## Addendum #1

Re: **Addendum No. 1**  
Cary Main EMS  
819 Kildaire Farm Road  
Cary, NC 27511  
ADW Job No. 21046  
Wake County Bid #24-086

These clarifications constitute Addendum No. 1 and considered part of the Bid Documents. General Contractor shall see that their sub-contractors are in full receipt of the information contained herein.

**A005**

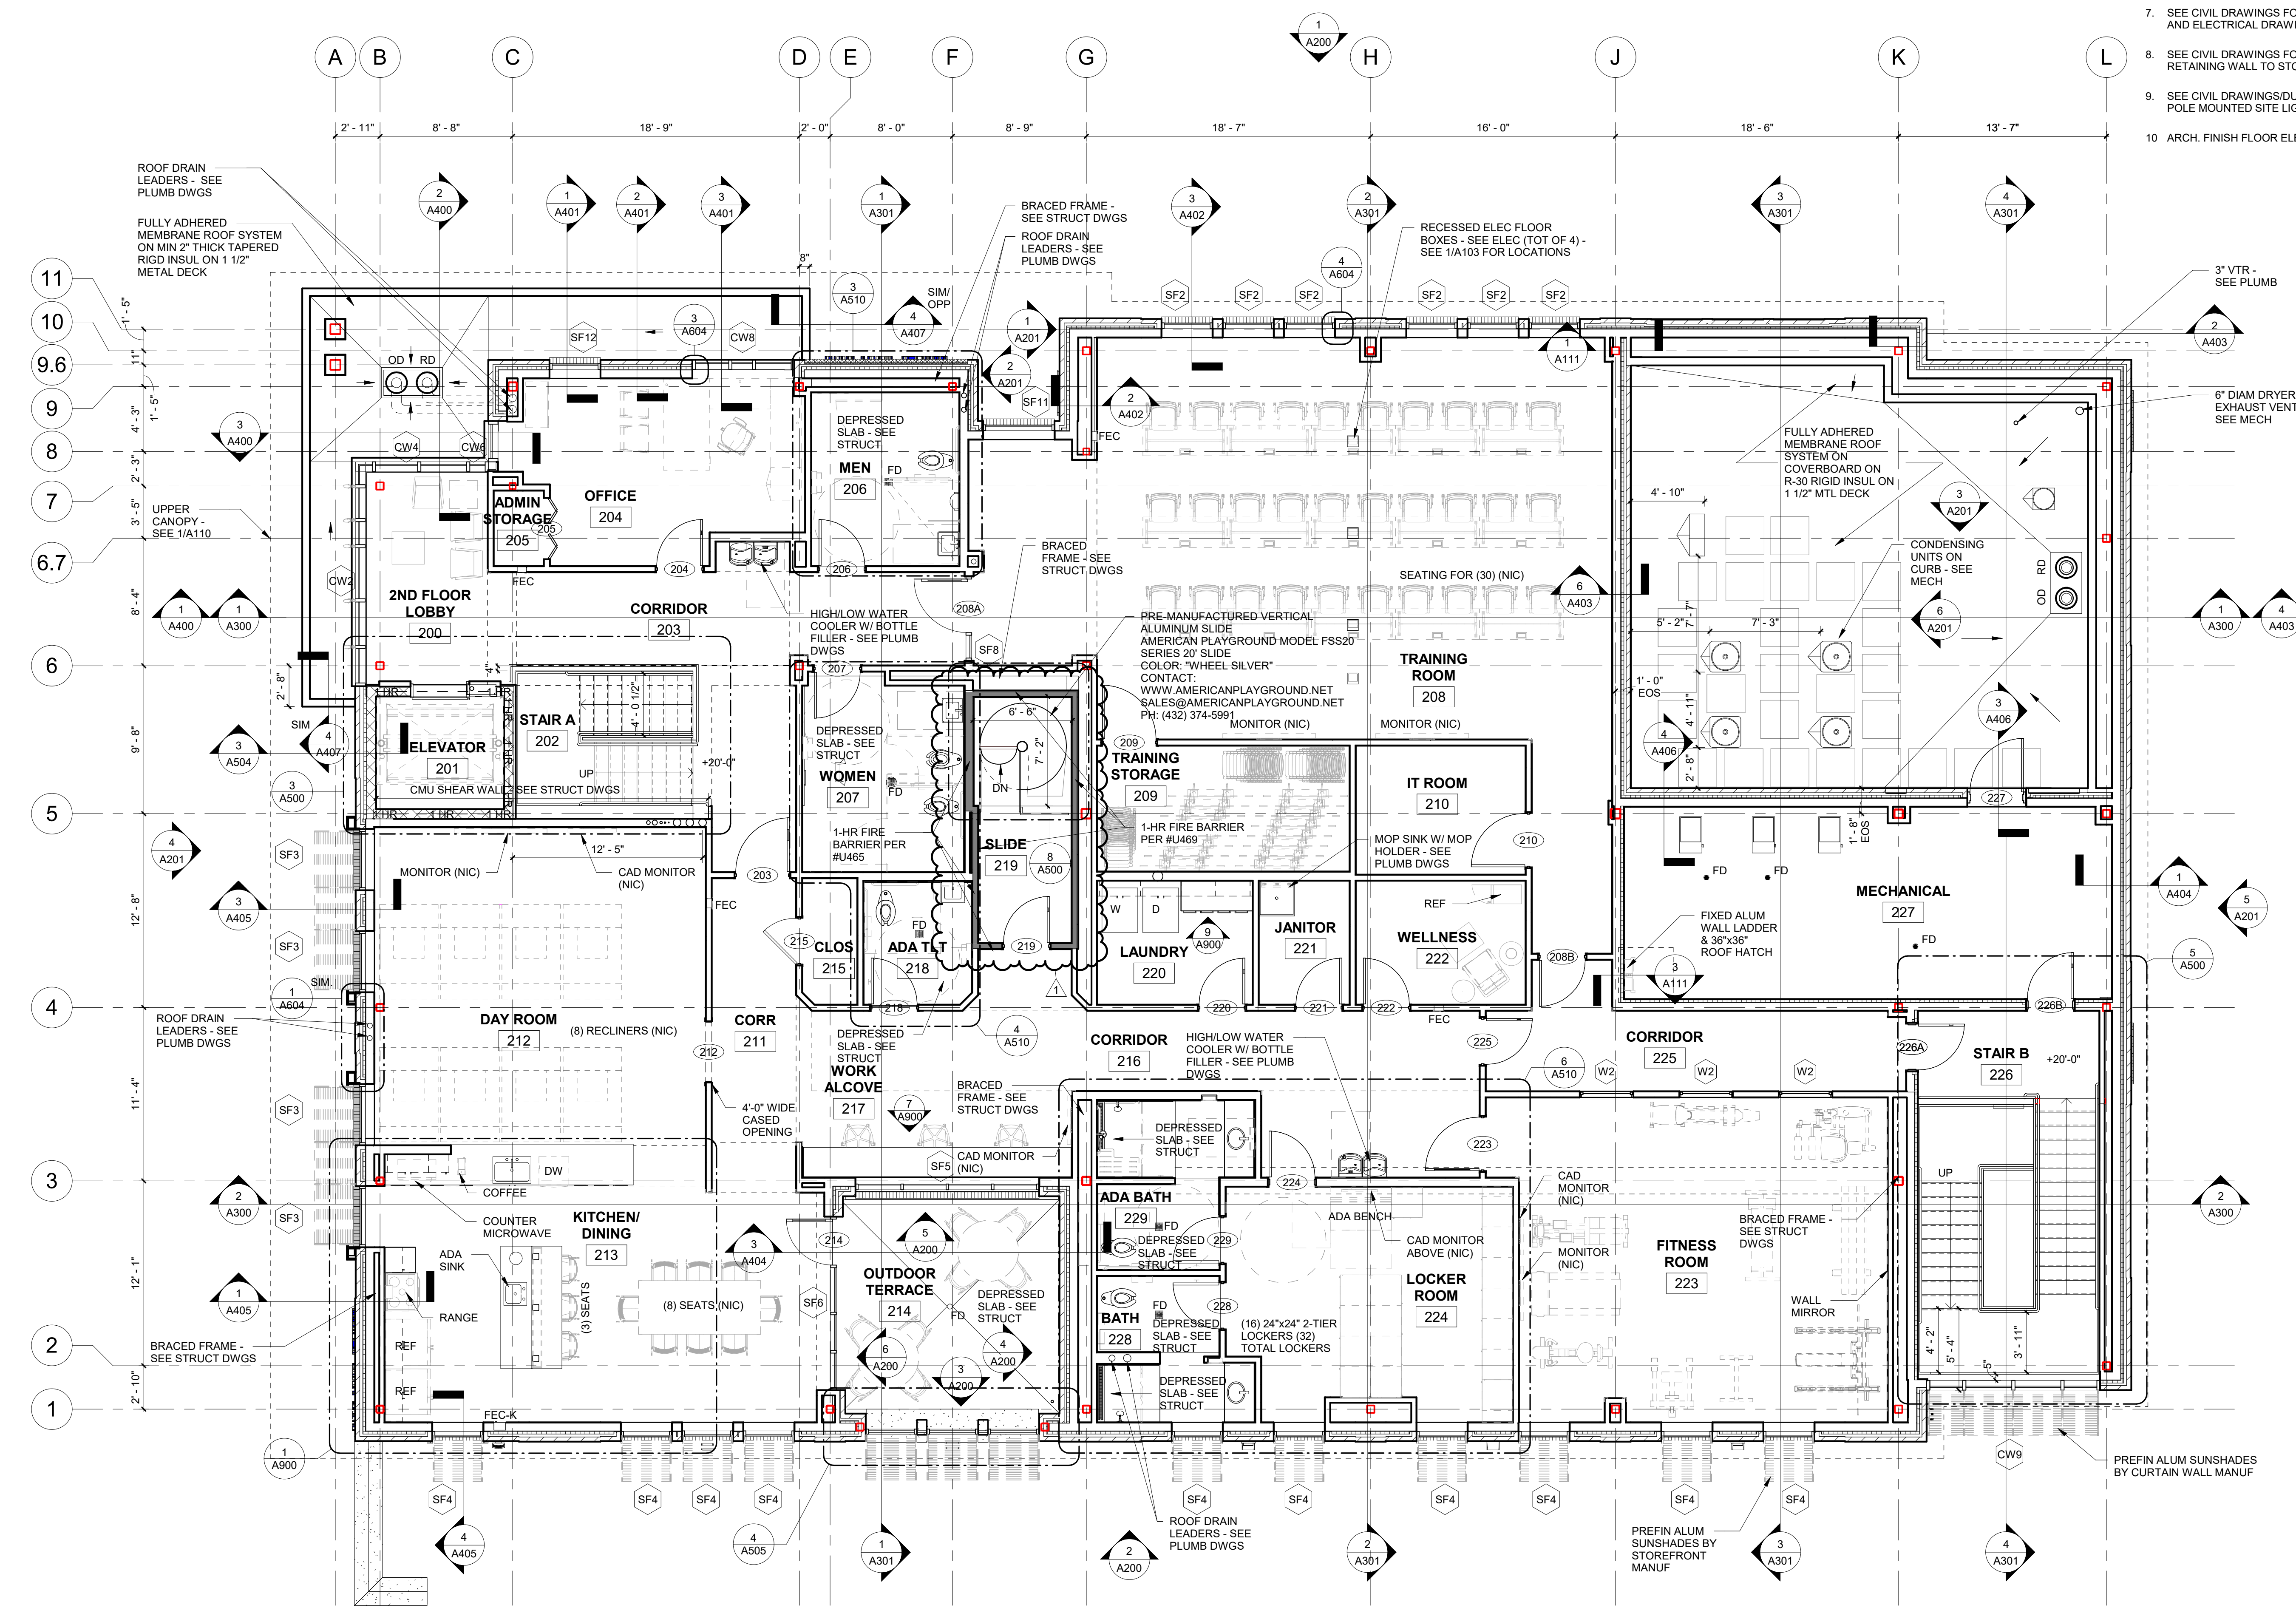
- 5.) See attached revised sheet A005. UL detail U469 has been added for 1-hr shaft wall.
- 6.) See attached revised sheet A006. UL detail U465 has been added for 1-hr wall.

ROOF HATCH DETAIL | 1 1/2" = 1'-0" 4

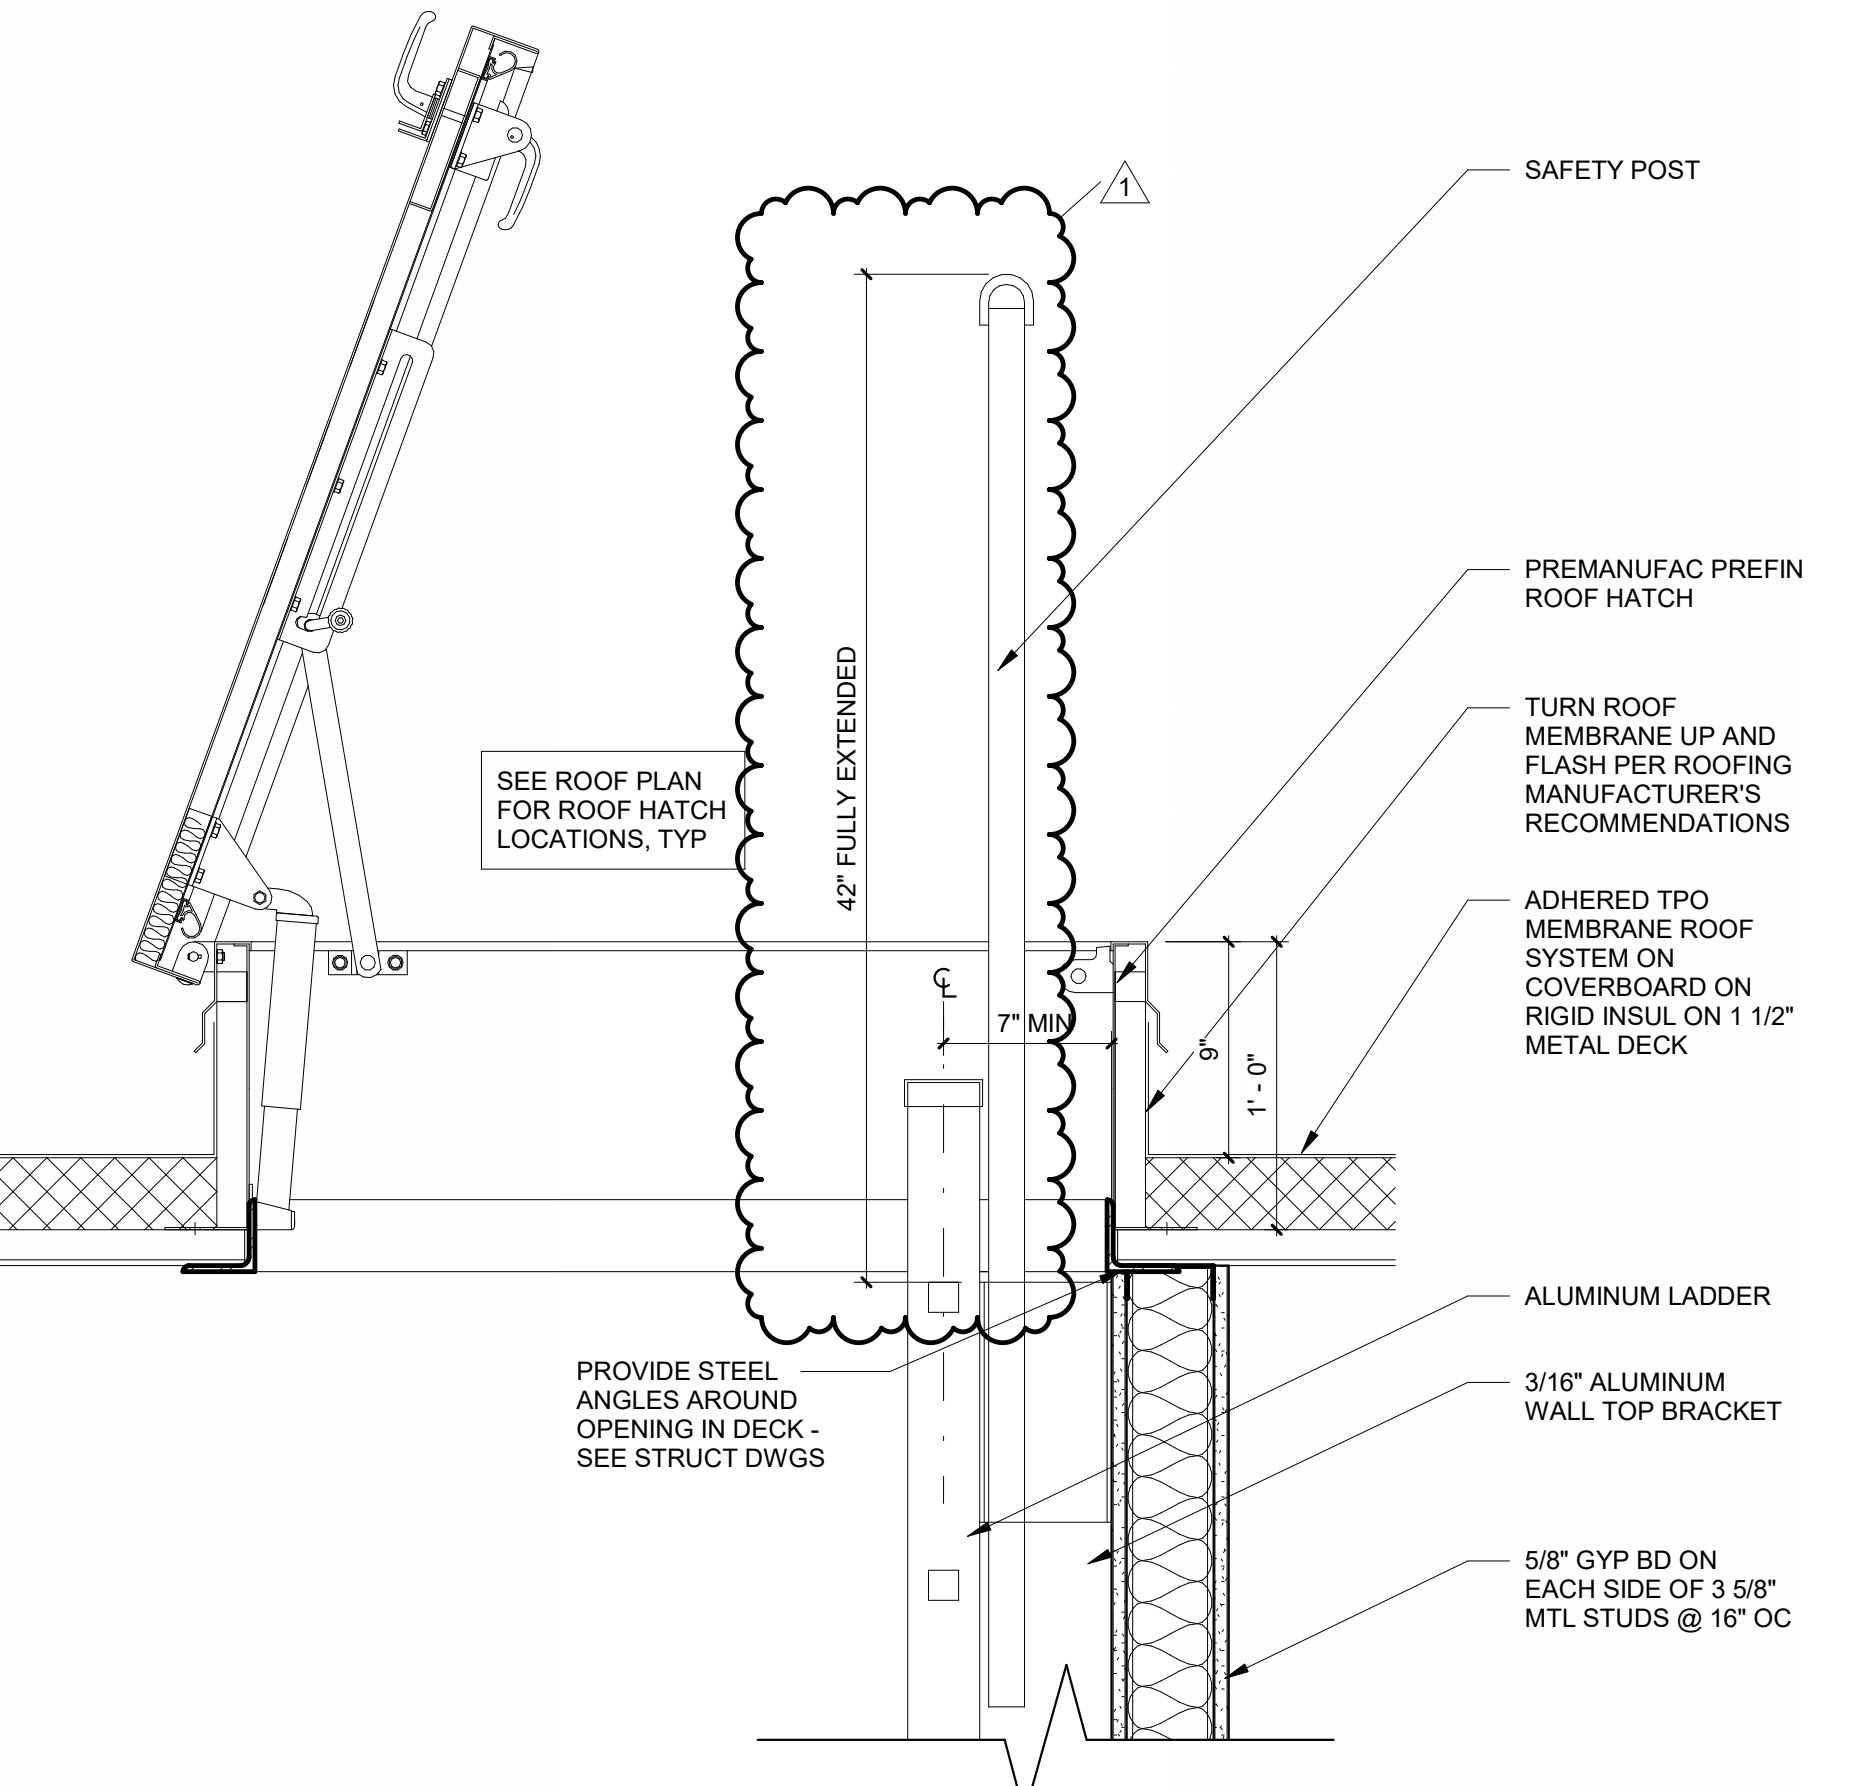
- 7.) Sheet A100: Change the note for the dual lock knoxbox to read as follows: “Recessed dual lock knox box 4446 series- mount 4’-0”aff (provide Wake County System Code PS-34-0058-93 for one of the cylinders (coordinate with Wake County Locksmith & Tommy Moorman with Wake FD&C), provide second cylinder keyed to Cary Fire Department (Coordinate with fire marshal).”
- 8.) See attached revised sheet A101. Walls enclosing slide 219 have been changed to 1-hr.
- 9.) See attached revised sheet A103 second floor dimension & wall types plan. Wall types around slide 219 have been revised.
- 10.) See attached revised sheet A110-roof plan. Note was added to roof hatch per permit comments.
- 11.) See attached revised sheet A111-roof details. Note was added to detail 3 roof hatch per permit comments.
